AGENDA
Cascade Charter Township Planning Commission
Monday, December 3, 2018
7:00 pm
Cascade Library Wisner Center
2870 Jacksmith Ave. SE

STAFF REPORT: Case #18-3502
REPORT DATE: November 27, 2018
PREPARED FOR: Cascade Charter Township Planning Commission
MEETING DATE: December 3, 2018
PREPARED BY: Steve Peterson, Planning Director

STAFF REPORT: Case # 18-3501
REPORT DATE: November 27, 2018
PREPARED FOR: Cascade Charter Township Planning Commission
MEETING DATE: December 3, 2018
PREPARED BY: Steve Peterson, Community Development Director

Re: Lacks 5801 Kraft Avenue
Site Plan Review

Lacks 5801 Kraft Avenue

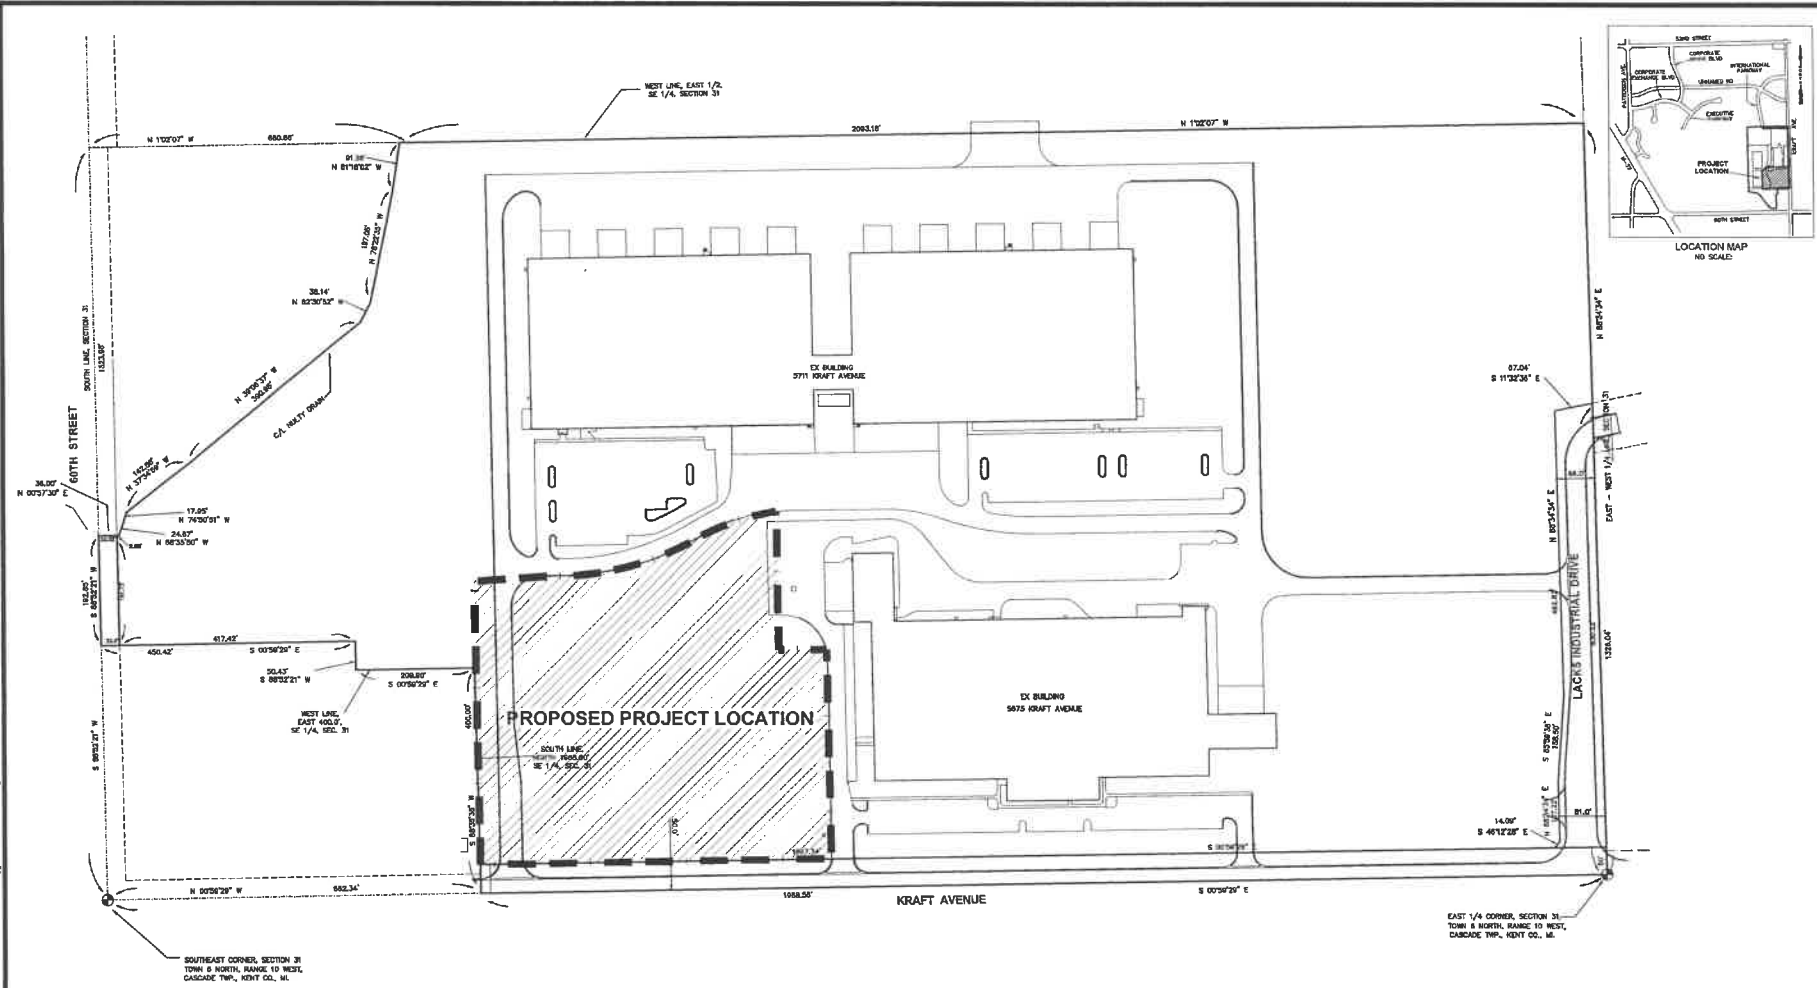
An area of offsite drainage enters the site from the east. The applicant provided a figure indicating this offsite drainage area to be 59.6 acres. A drainage swale traverses the property from the northeast to the southwest. The site plan proposes to enclose this drainage swale in a 36-inch storm sewer pipe and route it around the proposed development. The applicant provided stormwater runoff calculations for the offsite area and sized the storm sewer pipe for the 10-year storm event.

- NR (11) Maintenance agreement, in form and substance acceptable to the Township, for ensuring maintenance of any privately owned storm water runoff facilities. The maintenance agreement shall include the developer's written commitment to provide routine, emergency, and long-term maintenance of the facilities and, in the event that the facilities are not maintained in accordance with the approved drainage plan, the agreement shall authorize the Township to maintain any on-site storm water runoff facility as reasonably necessary, at the developer's expense
Maintenance agreement was not provided and is required.

The applicant has submitted plans, calculations, and additional documentation as required in SWO Section 2.03, Drainage Plan. Please refer to the attached checklist for items and comments on each item. Please note a maintenance

agreement is required before construction begins. The agreement should be submitted to the Township for review. The maintenance agreement and plan should include at a minimum, cleaning of catch basin sumps, sediment and debris removal from the detention basin and outlet structure, and landscape maintenance of the detention basin to maintain the design volume and ensure the system is operating as it was designed.
